ADDENDUM NO. 2

REQUEST FOR QUOTATIONS (RFQ) NO.:	**1220-040-2016-046**
TITLE:	**HOLLAND PARK CONCRETE PAVING WORKS**
ADDENDUM ISSUE DATE:	**APRIL 14, 2016**
CLOSING DATE:	**PREFER TO RECEIVE QUOTATIONS ON OR BEFORE APRIL 15, 2016.**

SHEET NO. LP-3

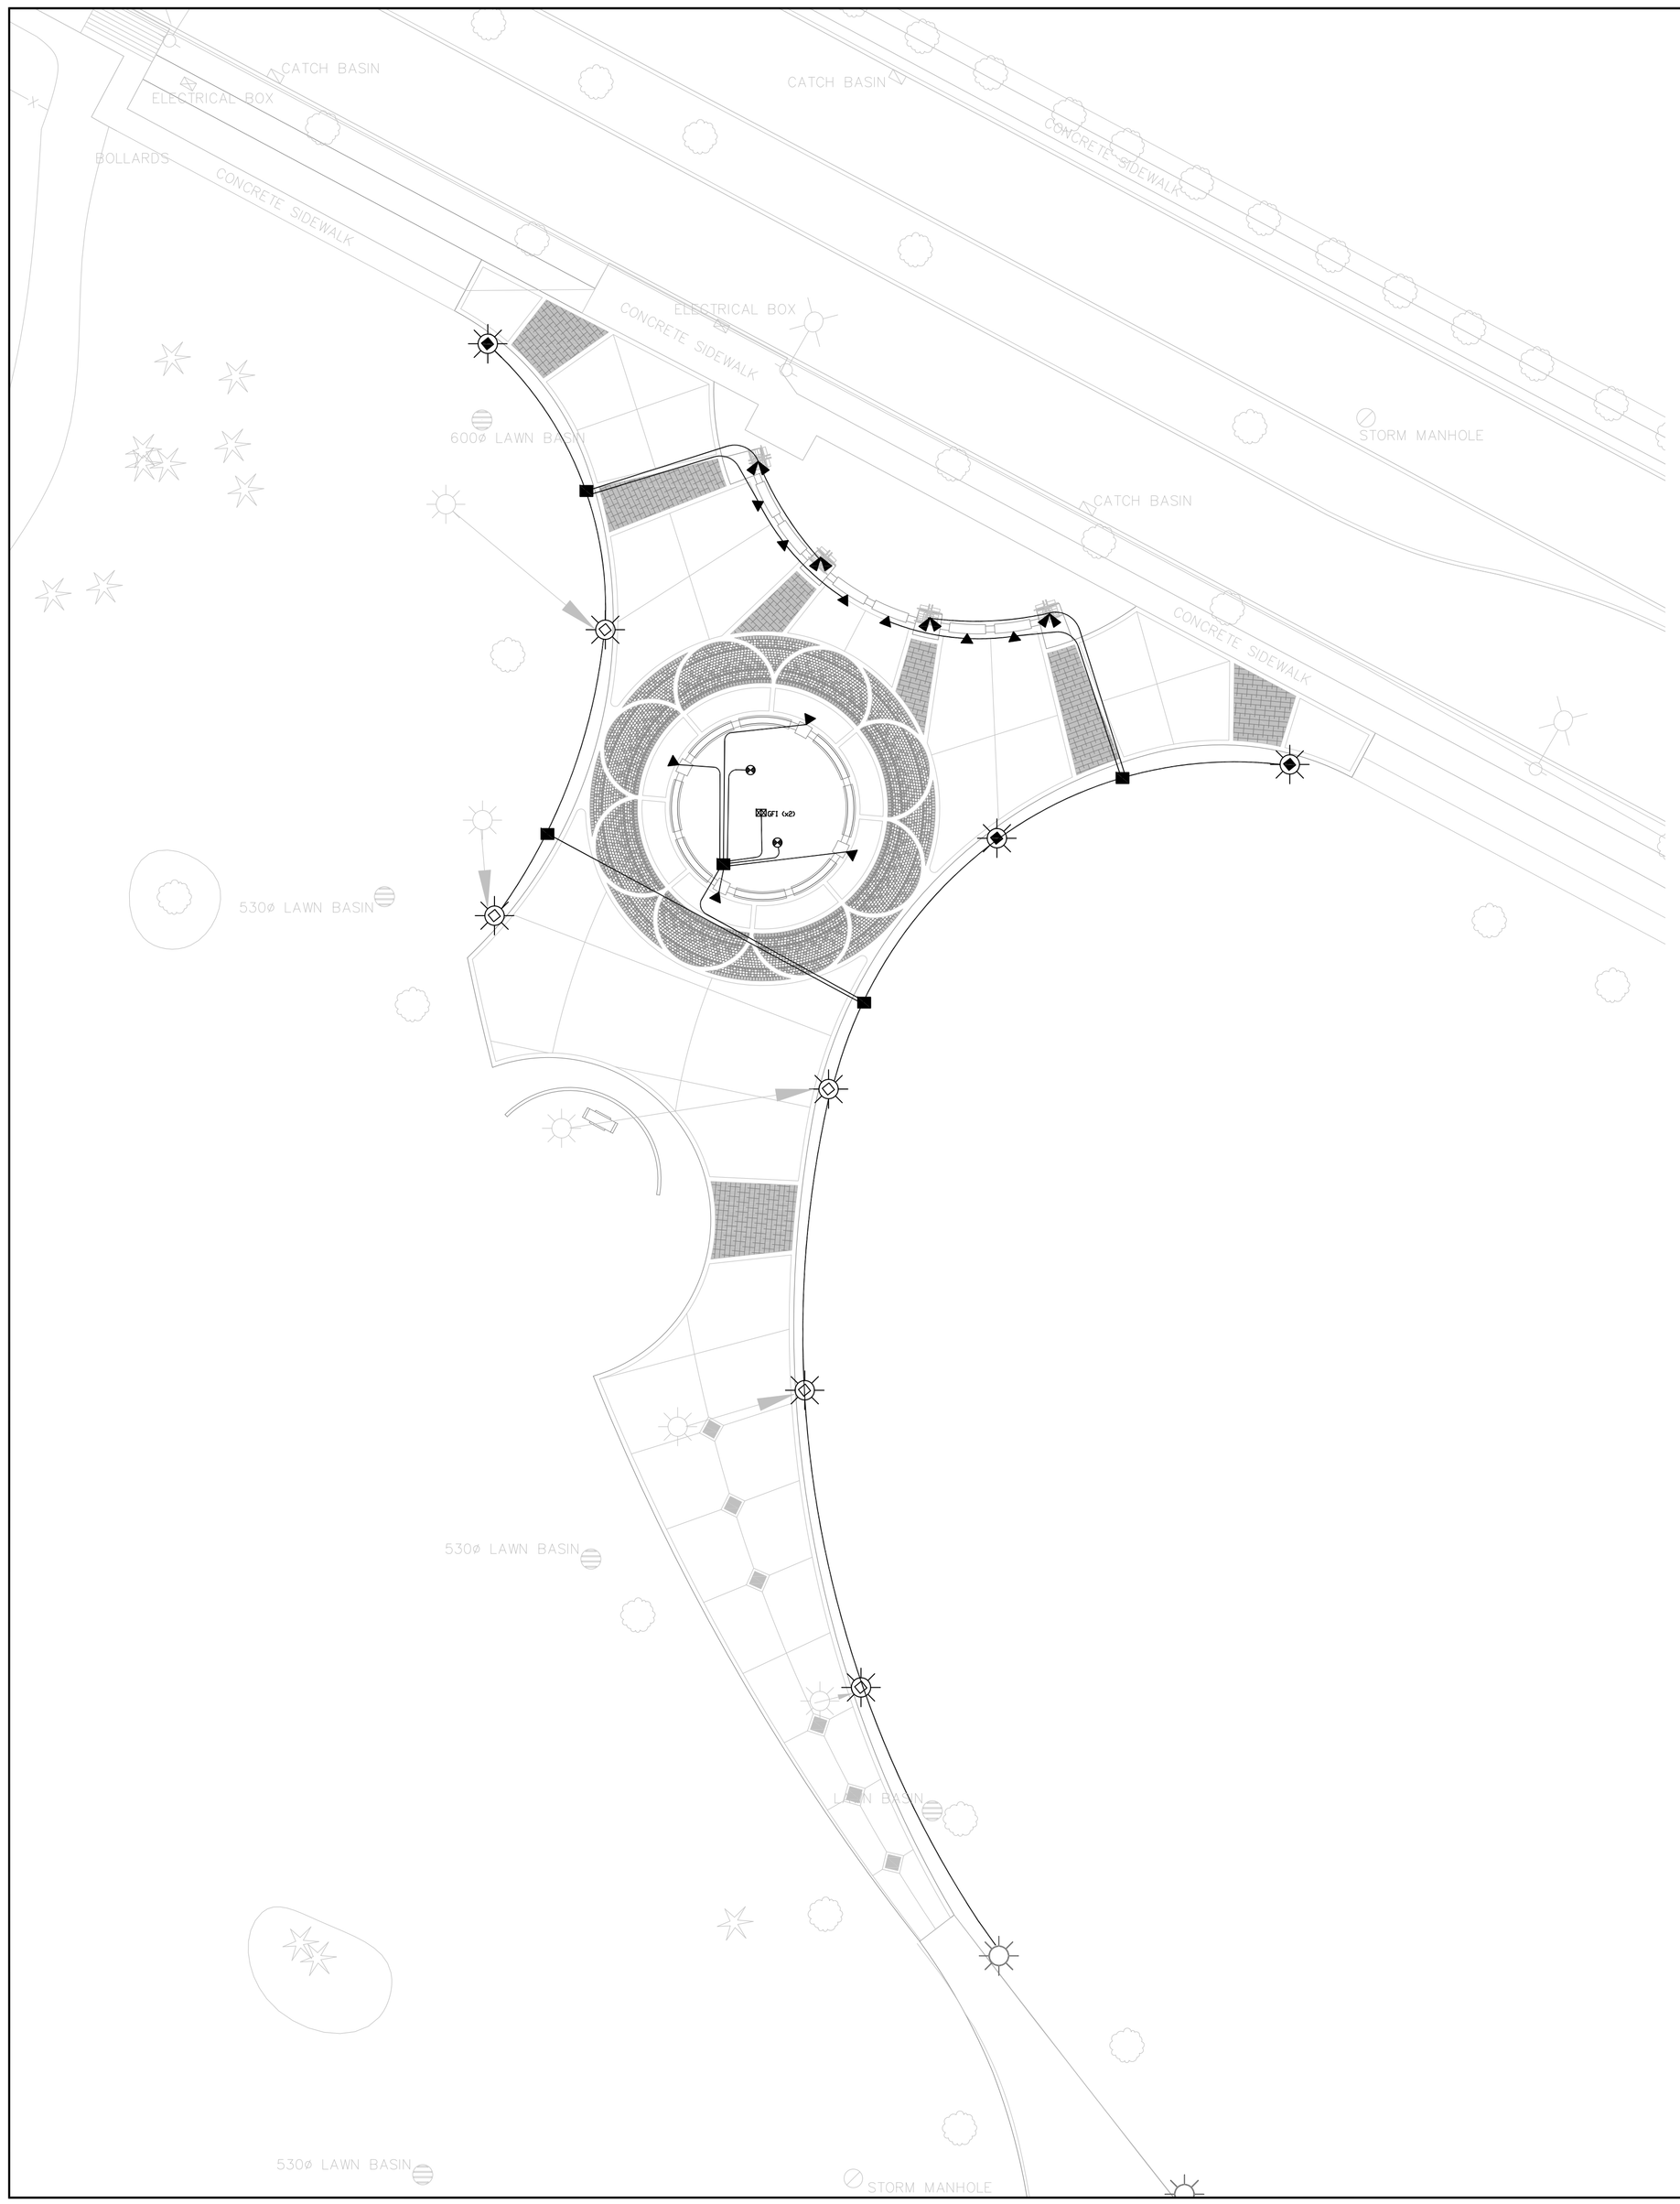
Q1b: May we be supplied with current as-built electrical drawings before tender close?

Q1c: What does this electrical infrastructure supply power to?

Q1d: Is this the only electrical service within the construction area?

A1b: All available as-built electrical drawings are attached to this addendum.

A1c: Existing electrical infrastructure in this location supplies power to the lamp standards along the east side of the existing concrete surfaces, as well as a junction box with power heading west under the concrete to the round planting island to power some landscape flood lights and a pair of GFI plugs for Christmas lights on the Sequoia tree. There is another junction box that heads north toward

the bus shelter on Old Yale Road where it powers four spot lights on the black steel poles framing in the north end of the plaza as well as some flush mounted plaza lights in the concrete seat walls.

There is also a pull box (in the lawn area to be excavated) that has two empty 4" conduits coming into it for supplying temporary underground event power through a bolt down power kiosk. These do not have any conductors in them and pose no hazard to excavating.

A1d: On the opposite side of the path to the west is a 600 Amp BC Hydro service transformer and a large above ground power kiosk for large concert events. Live power does not extend beyond that service. The park's path lighting is powered from the east end of the park near the fountain.
